## ORIGINATION FORM

Proposed Revisions to a Standard Plans Index  
(Please provide all information — Incomplete forms will be returned)

Index Number: 646-001  
Sheet Number (s): 1 of 1  
Index Title:  
Aluminum Post and Pedestal Mounted  
Pedestrian Detectors and Signals

POST MOUNTED

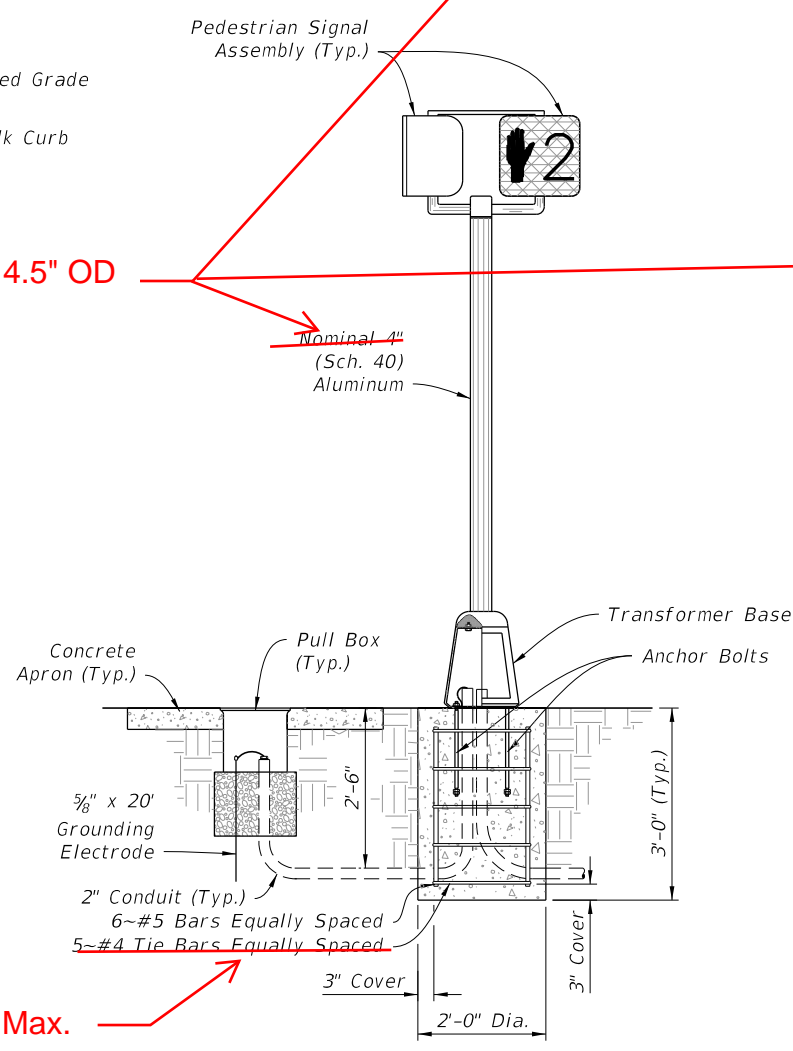
Updated the PEDESTAL MOUNTED detail - to show in the ADJACENT TO SIDEWALK detail "Tie Bars" callout as a #4 Stirrups equally spaced, with a 12" maximum spacing and change all references "4" Nominal Aluminum Pole" to "4.5" OD Aluminum Pole;

**CHANGED TO: #4 Stirrups Equally Spaced, 12" Max.**

PEDESTAL MOUNTED

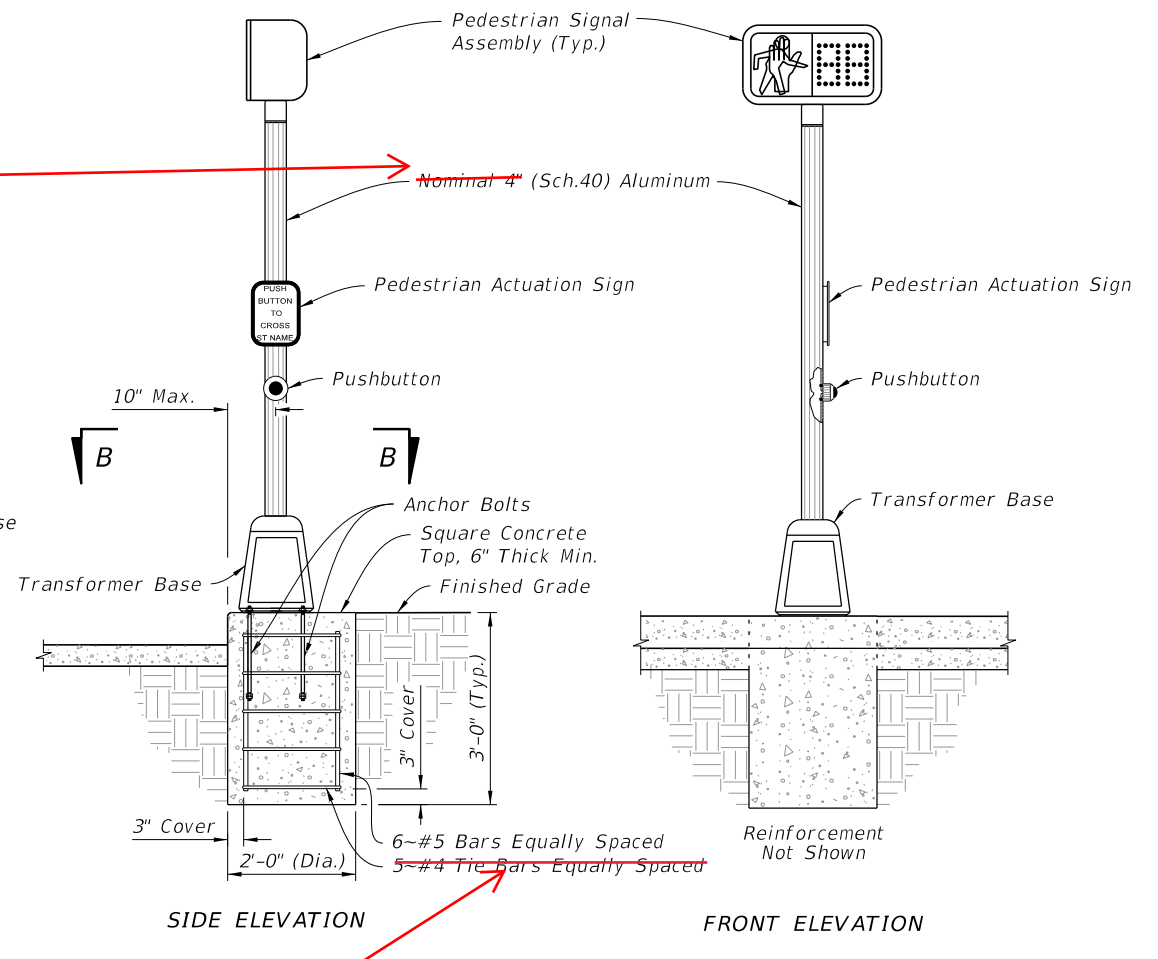
**CHANGED TO: #4 Stirrups Equally Spaced, 12" Max.**

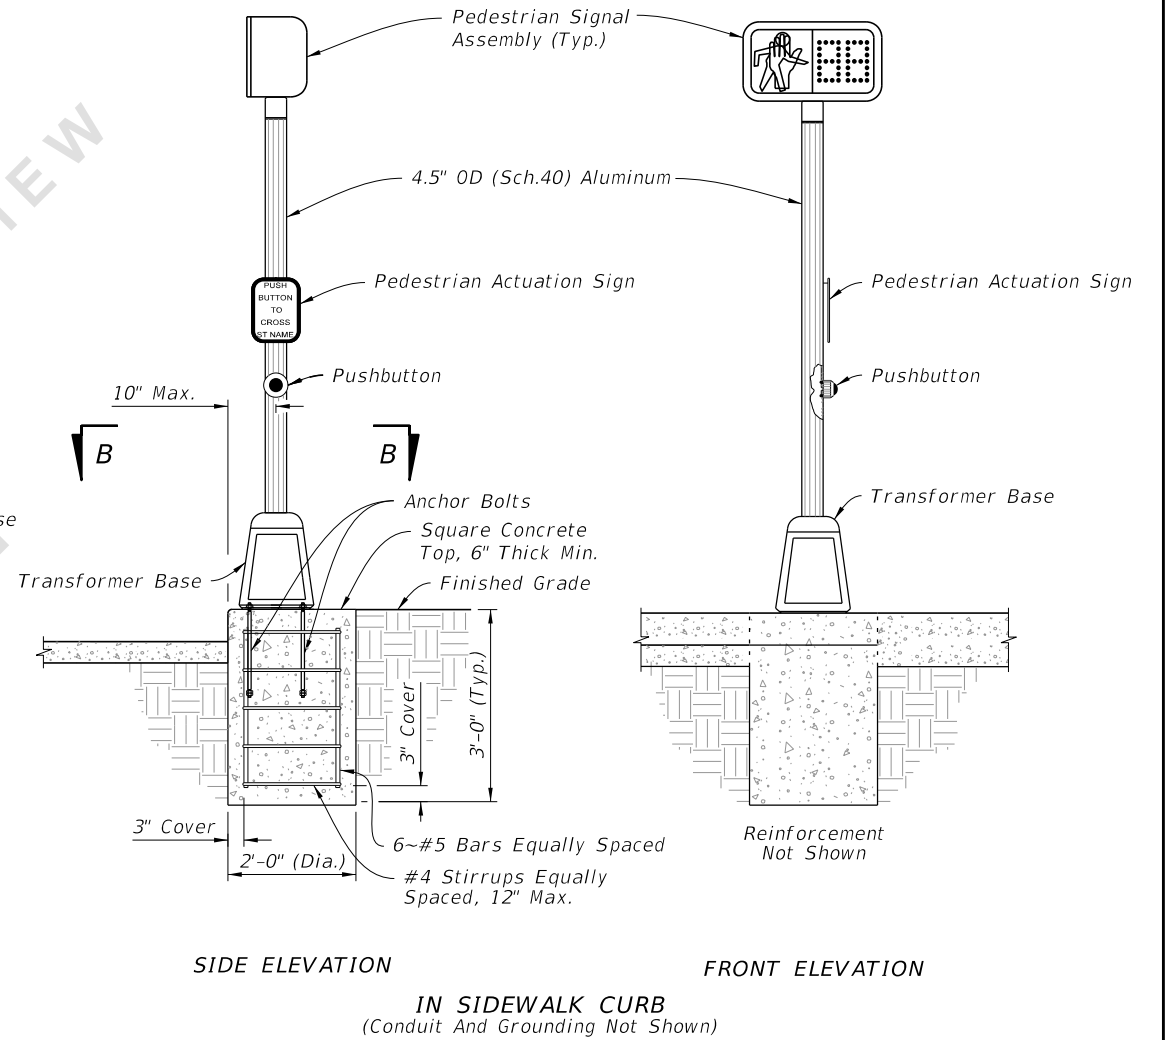
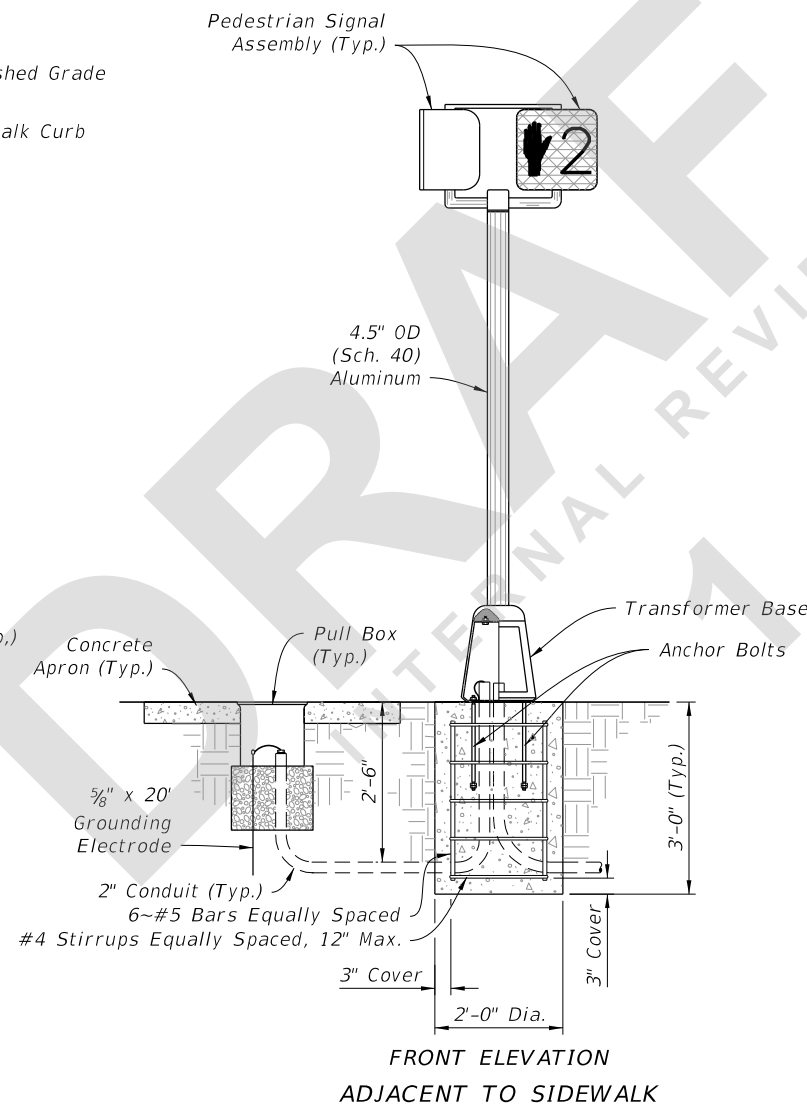
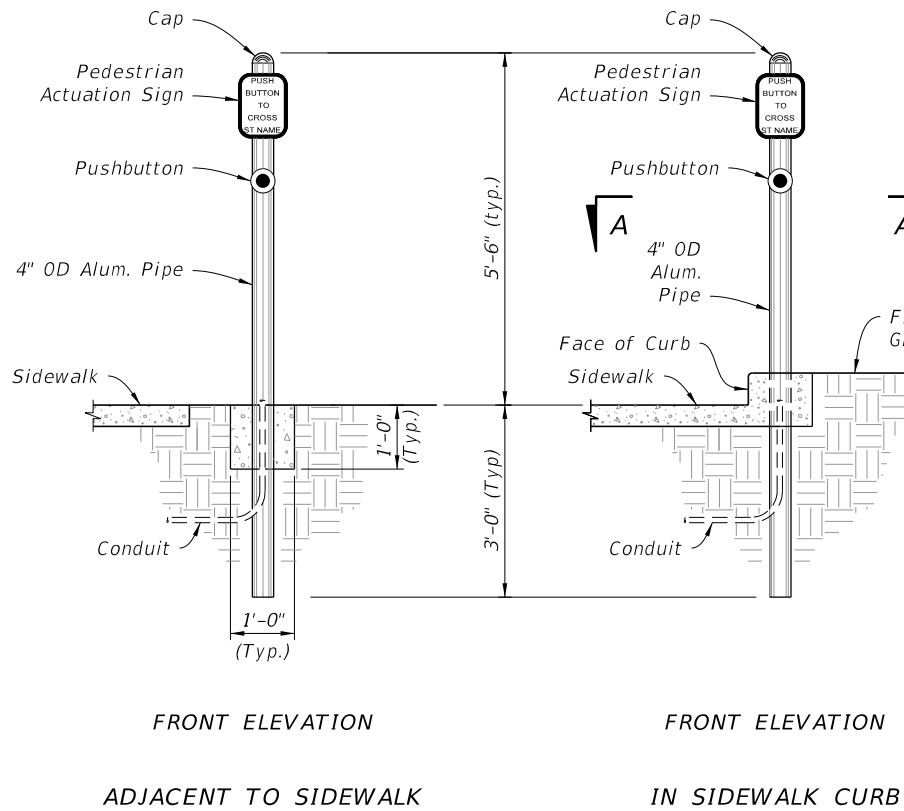
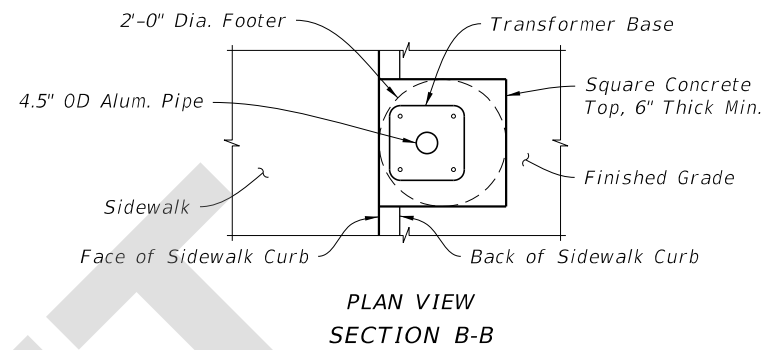
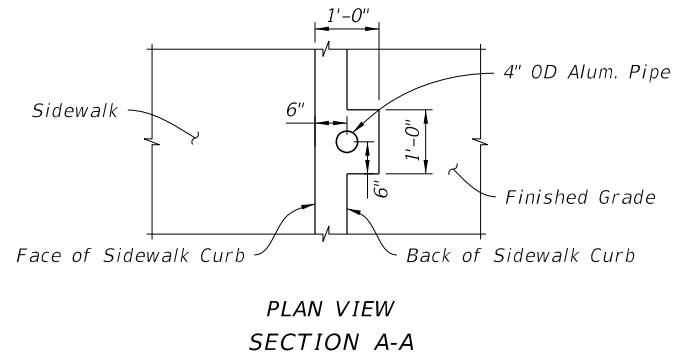
Changed Note 4 to remove concrete type since specified in Spec 646

Added Note 5 "As an alternative to the direct buried "Post Mounted" Pedestrian Detector Assembly shown below, the post may be installed on a transformer base. Use a transformer base included on the APL approved as an alternative to a "Post Mounted" assembly."

1. Work this Index with Specification 646.
2. For Pedestrian Signals see Index 653-001.
3. For Pedestrian Detector Assembly (i.e., Pushbutton and Sign) details see Index 665-001.
4. Footing may be Cast-In-Place (C-I-P) or Precast.
5. As an alternative to the direct buried "Post Mounted" Pedestrian Detector Assembly shown below, the post may be installed on a transformer base. Use a transformer base included on the APL approved as an alternative to a "Post Mounted" assembly,
